Summary of Proposed Amendments
Phase 2
Weldale Street, Reading

Non-Material Amendment Application

January 2022

This document summarises the changes made to the drawings associated with planning permission 170326 for the former Wickes Site, Reading

Proposed Lower Ground Floor Plan, 1:500 (3622-SC-0199EE)

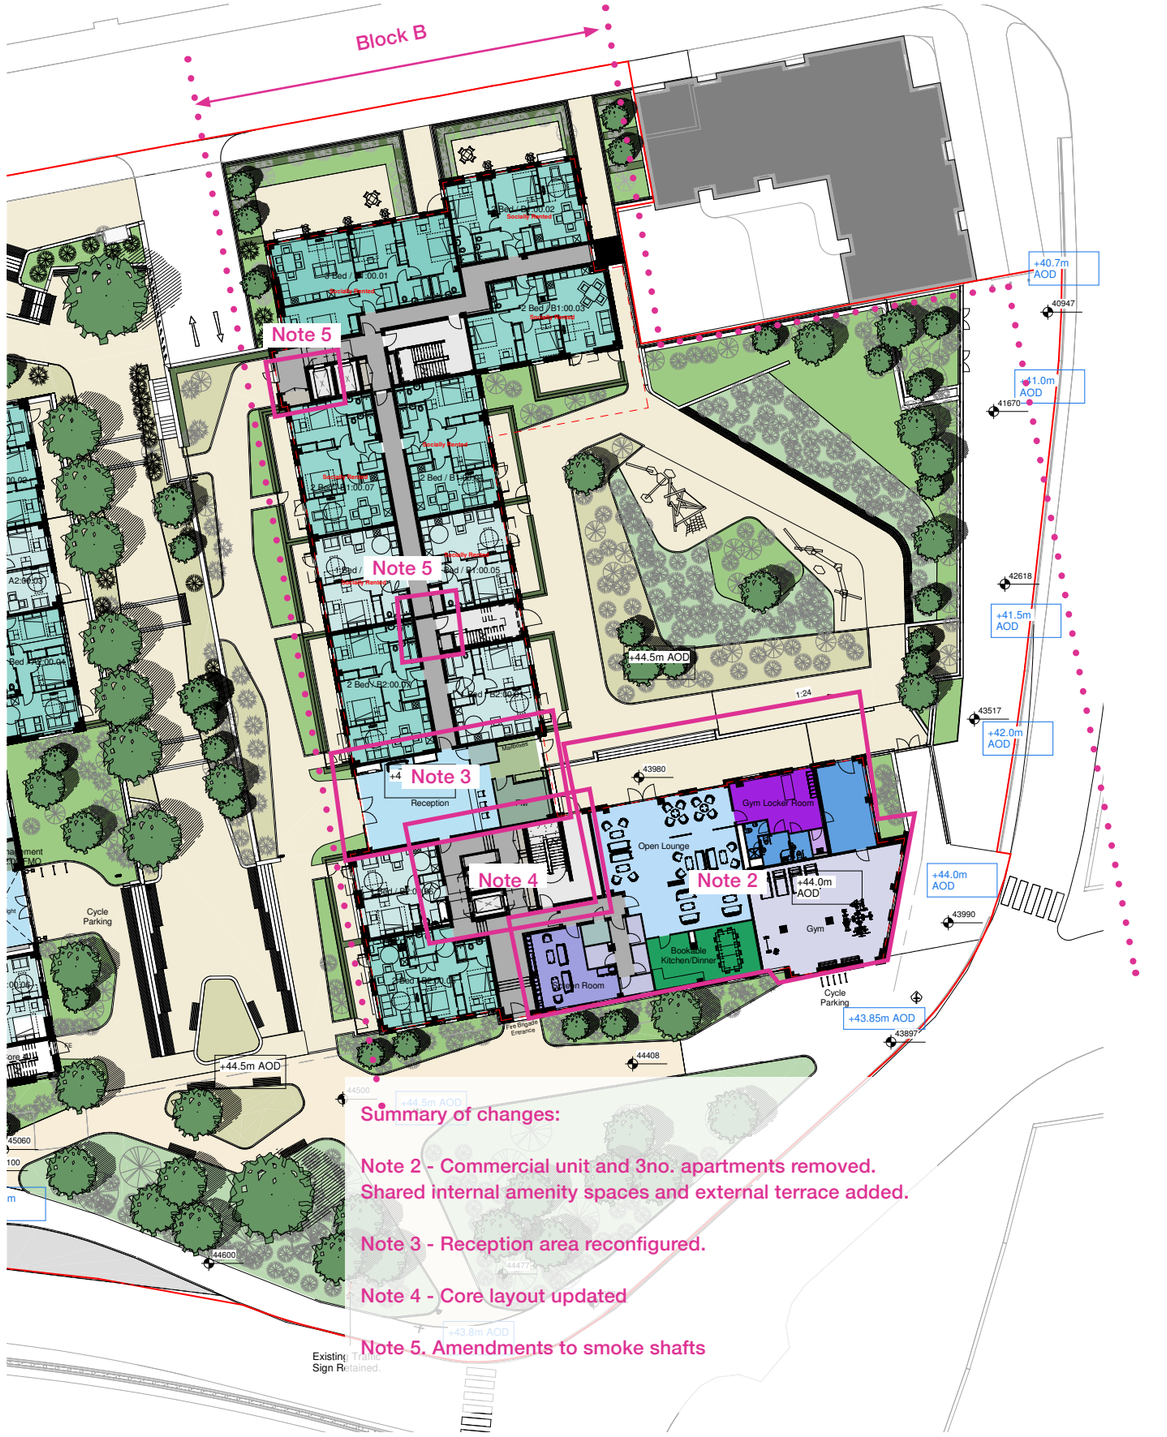
- Note 1 - As part of design development the commercial bin store and commercial plant areas have been removed.
- Due to new sprinkler recomendations for residentail building a new dedicated sprinkler tank has been added.
- CHP plant has been repaced with localised air source heat pumps requiring plant areas to be reconfigured.
- B1 Landscaping amended to suit updated levels.
- Carpark updated to suite layout changes, however carpark numbers to remain the same. Where space permits additional accessible spaces have been provieded.
- EV charging has been increased to provied on charger for every two spaces. these have been evenly distributed so all spaces can benifit from having access to a charger
- Note 1a - To ensure proper sprinkler cover to the below podium carpark a further additional sprinkler tank has been located below the predestrian ramp.

Extract from proposed West Elevation of Block A2, 1:200 (3622-B2-0303C

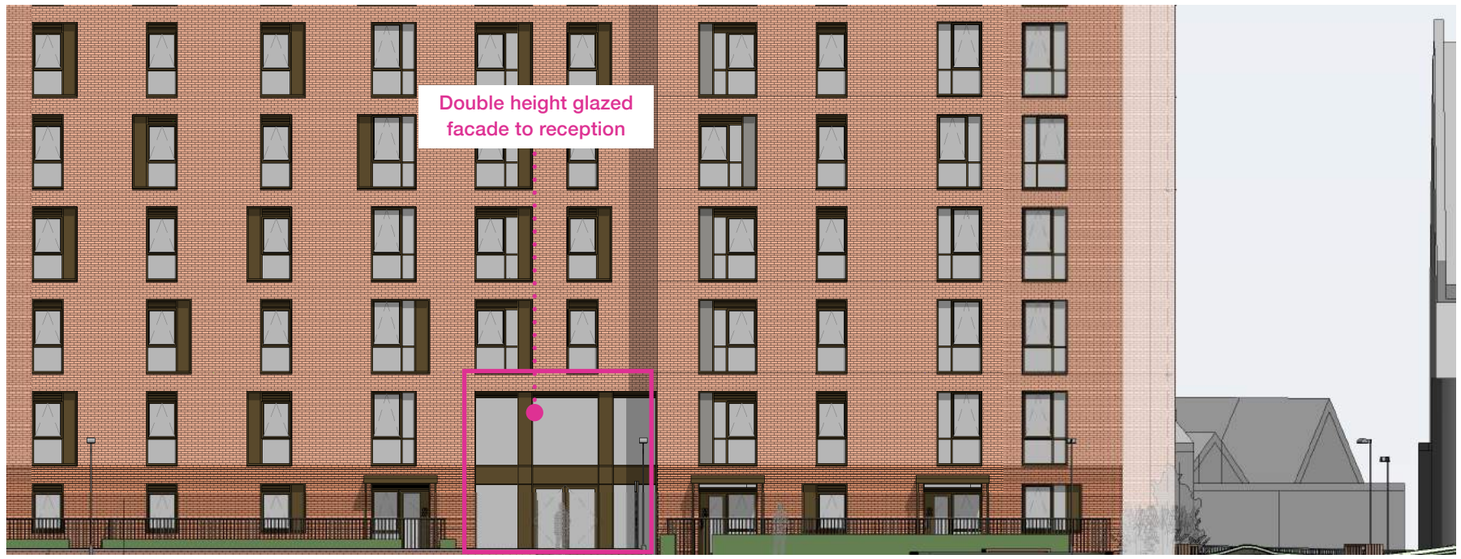
- Changes to reception & lobby area

An enlarged area of glazing is proposed to the south end of the west elevation of Block B to pick up the changes to the reception & lobby areas. This is to maximise light and views in and out of the double height reception space and increase the visual impact of the main entrance externally. This helps improve the legibility of the main entrance to Block B.

- Introduction of shared amenity spaces

An enlarged area of glazing is proposed within the courtyard to the south end of the east elevation of Block B This is to express the shared internal amenity spaces at the ground floor level and maximises light and views in and out of these communal areas, Glazed doors within the curtain walling also provide direct access for the residents to spill out into the external amenity space of the courtyard.

Where ground floor levels have been modified fenestration has been updated to suit whilst remaining similar to the approved scheme.

Glazed facade to shared internal amenity spaces updated to suit new levels

Extract from proposed Site Elevation South, 1:200 (3622SC-0300G),

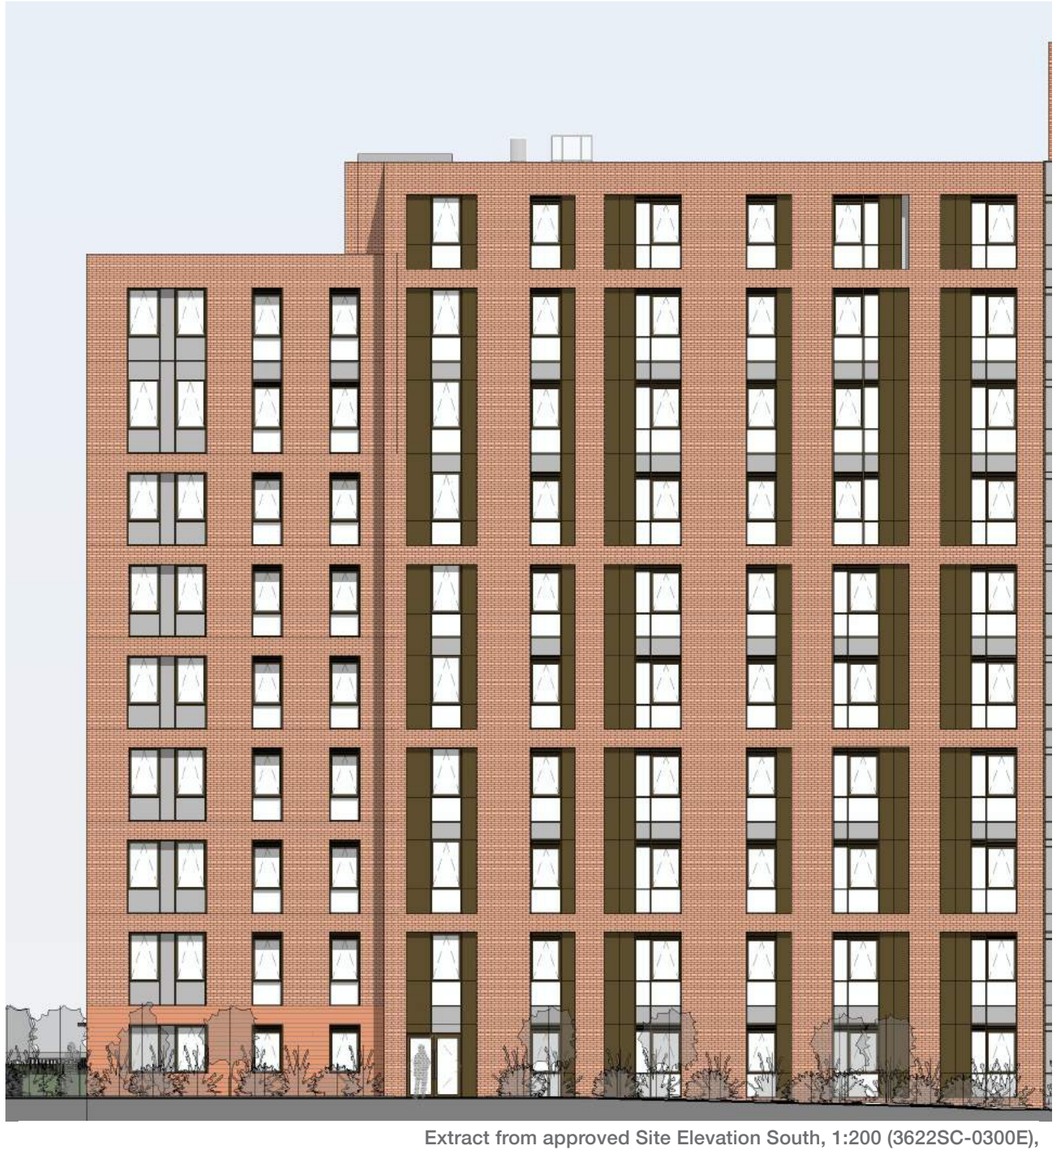
- General design development

The setting out of fenestration has also been rationalised slightly on a number of elevations. This is mostly in responce to updated levels, Firebrigade access and escape stair improviments.

Fenetration updated to rationalize windows and allow for reception back of house area

Extract from Proposed Site Elevation - East, 1:500 (Drawing 3622-SC-0303F

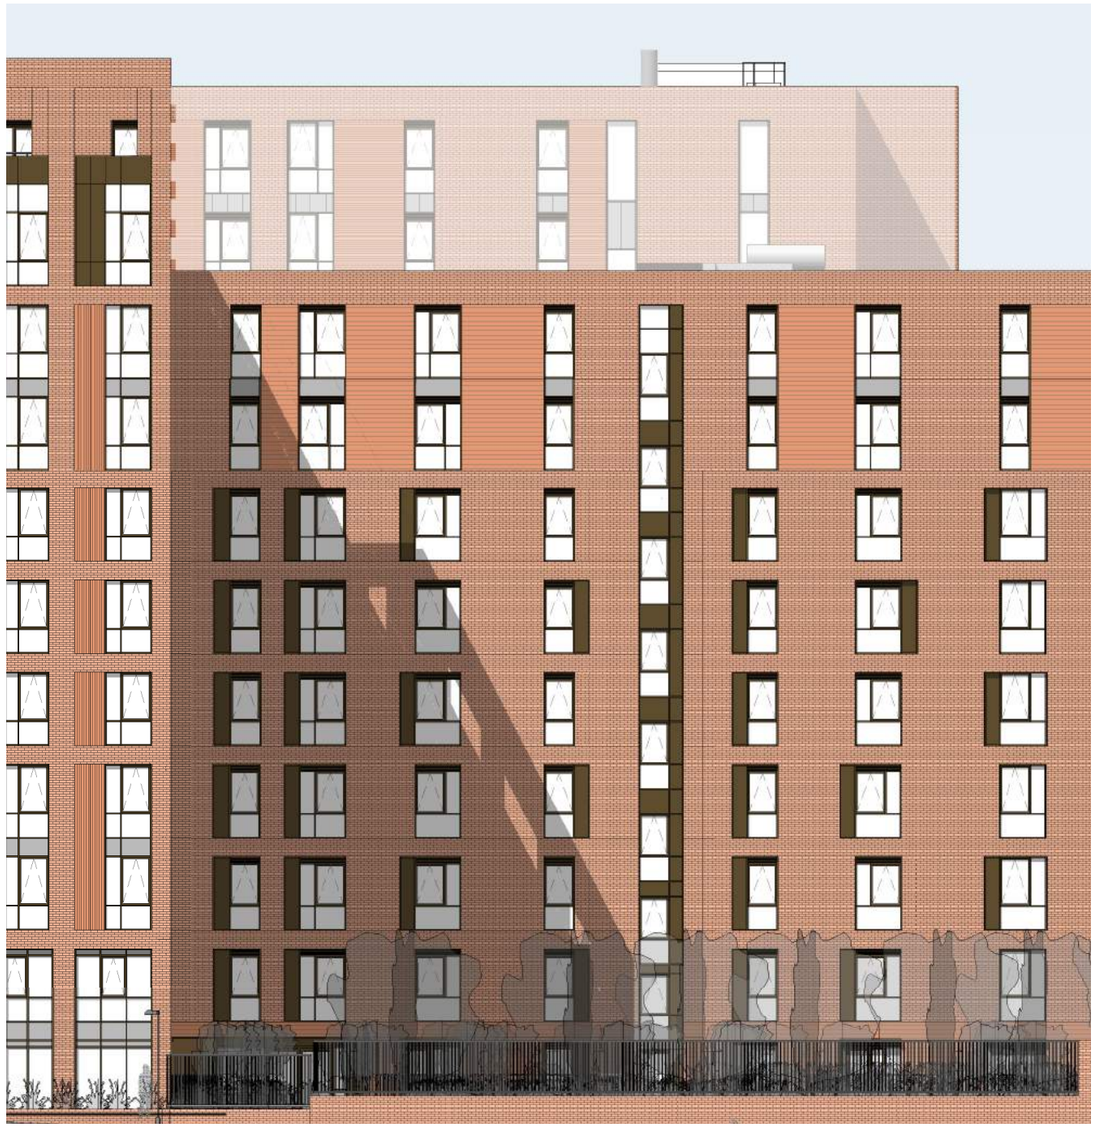
PVs + Edge Protection to roof areas

windows rationalised to suit fire escape half landdings

Fenetration updated to suit updated reception area

Proposed Extract of B1/B2 West Elevation, (Drawing 3622-SC-0405F)

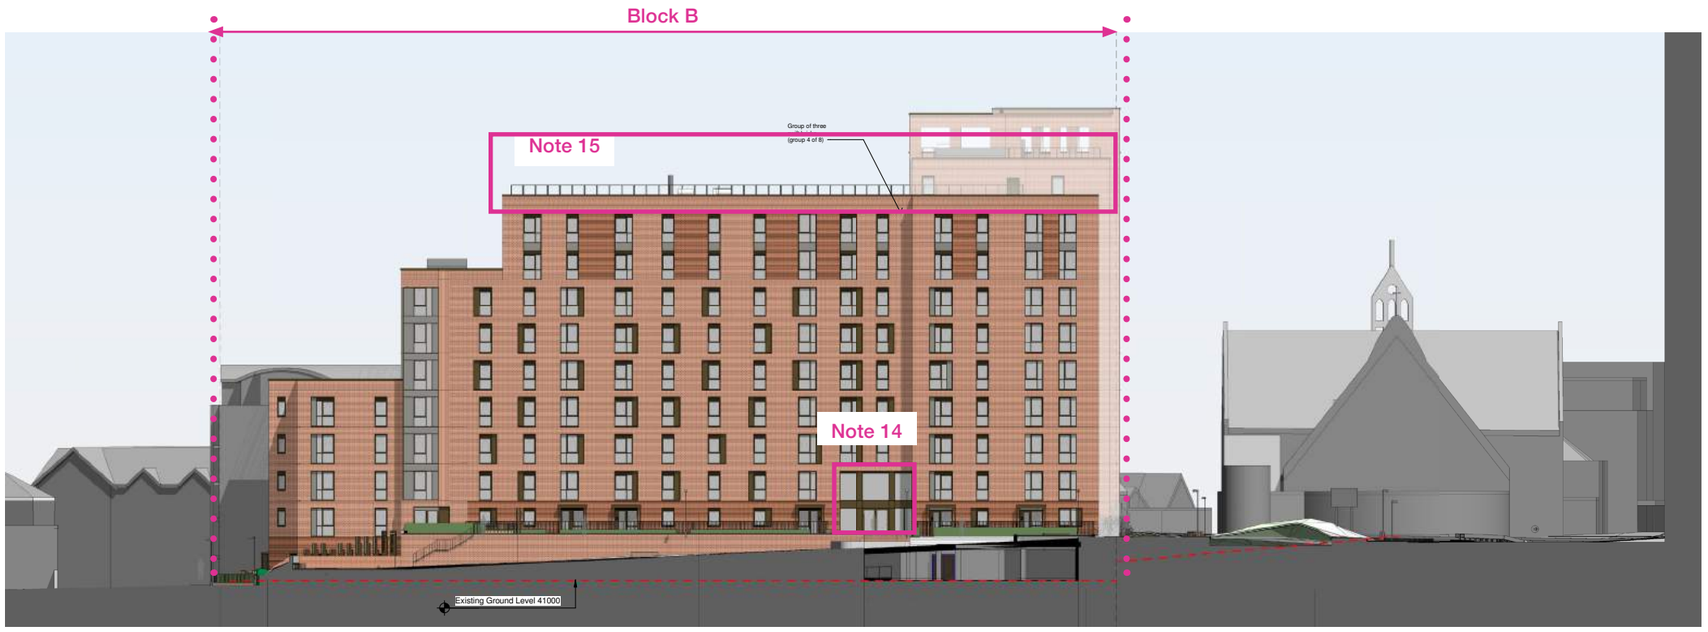
Note 14- Fenestration updated for double height reception space.

Note 15- PVs + Edge Protection to roof areas
